PLANNING COMMISSION MEETING

Planning Commission

City of Decatur, AL

Planning Commission Staff Report

PRELIMINARY PLAT MAP -

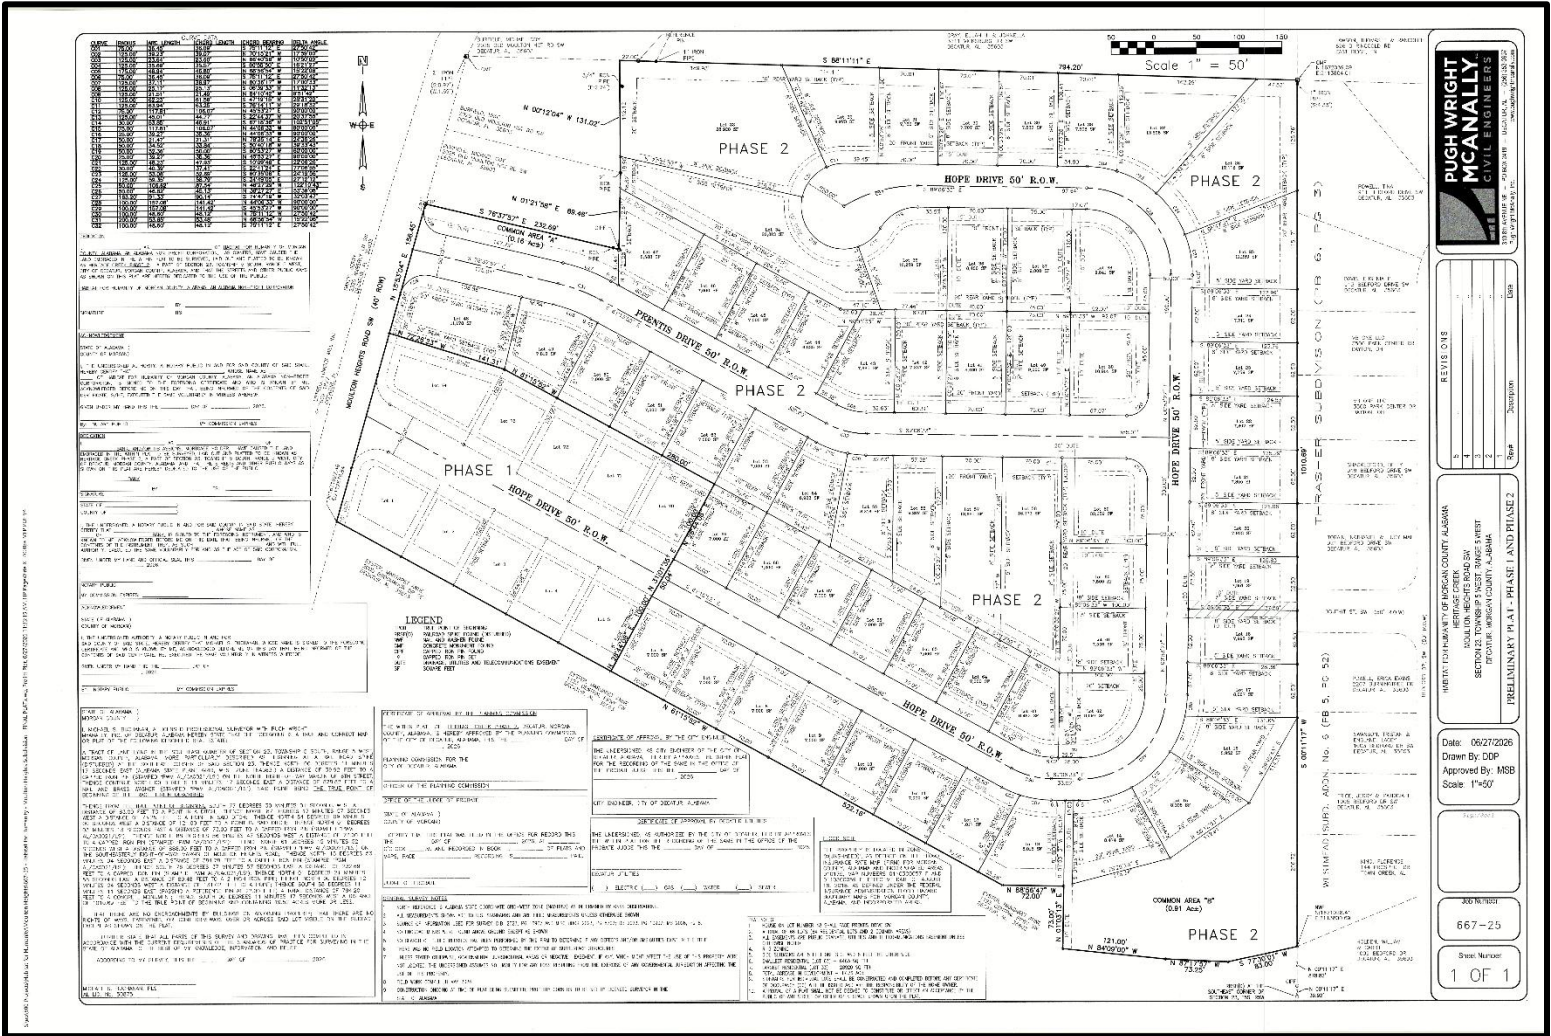
1. Add separate access that meets IFC D104.3 specifications. (Two separate and remote fire apparatus access roads are required in one or two family residential developments with 30 or more dwelling units. See IFC Appendix D, D104.3 Remoteness. As shown, the two access roads do not meet the separation requirements.)

SKETCH PLAT
of
IDLEWIND SUBDIVISION

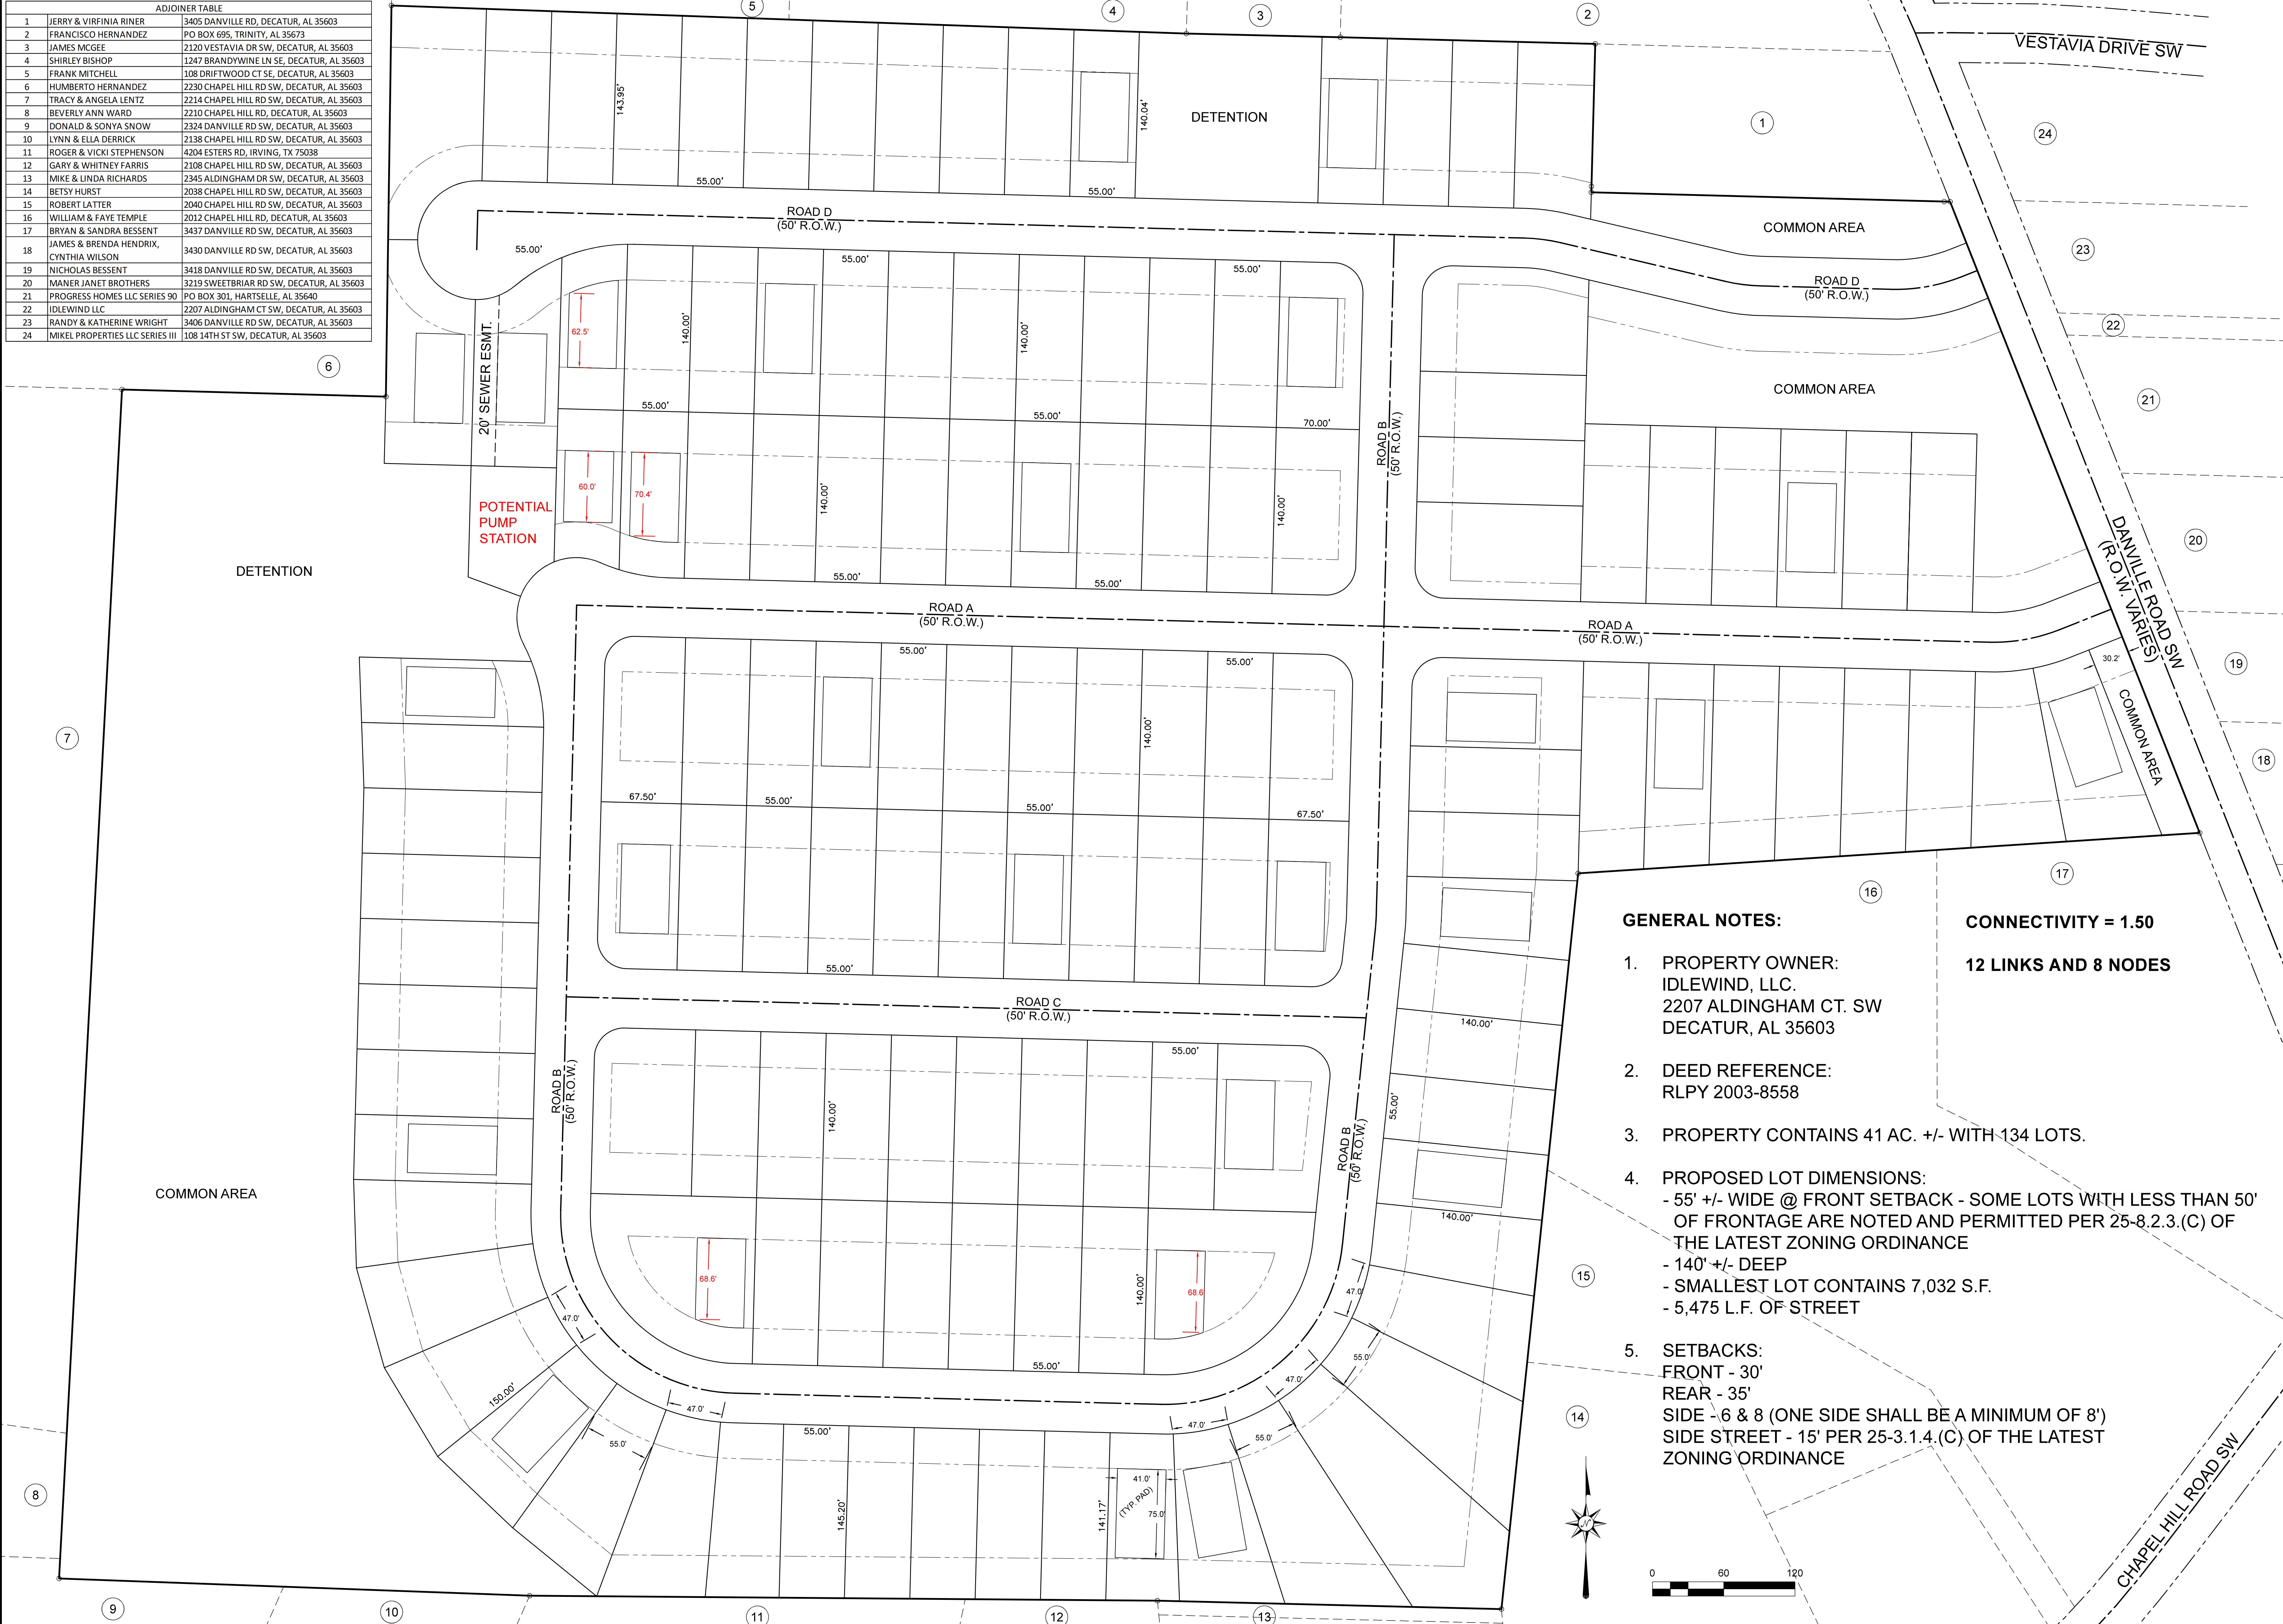
“Table 25-5.1.6(A)(2)(III): REQUIRED DEVELOPMENT ENTRY POINTS” of the Zoning Ordinance requires subdivisions containing 80 or more lots to provide a minimum of two points of ingress and egress to promote connectivity, improve emergency access, and distribute traffic more efficiently. As submitted, the proposed layout does not comply with this requirement, as only one access point is provided.

1. Please ensure that the connectivity index is greater than 1.5
2. Please add adjoining property owners to the plat.
3. A Traffic Study must be submitted to Planning for review. Final approval may only be granted once the study has been reviewed and approved. If the Traffic Study identifies any issues, a revised and appropriately amended Sketch Plan must be resubmitted before the project can proceed to the Preliminary Plat phase.

1. Additional fire access road is required. (Two separate fire apparatus access roads are required for residential developments with 30 or more dwelling units. See IFC 2021 edition - 102.5 Application of residential code, #1., 503.1.2 Additional access., Appendix D, D107.1 One or two family residential developments., Appendix D, D104.3 Remoteness.)
2. Show diameter of each cul-de-sac turn around. (There are two cul-de-sacs shown on the sketch. A minimum diameter of 96' is required to allow fire apparatus to turn around, in a cul-de-sac. See IFC 2021 edition – Appendix D, Figure D103.1 Dead-end fire apparatus access road turnaround.)
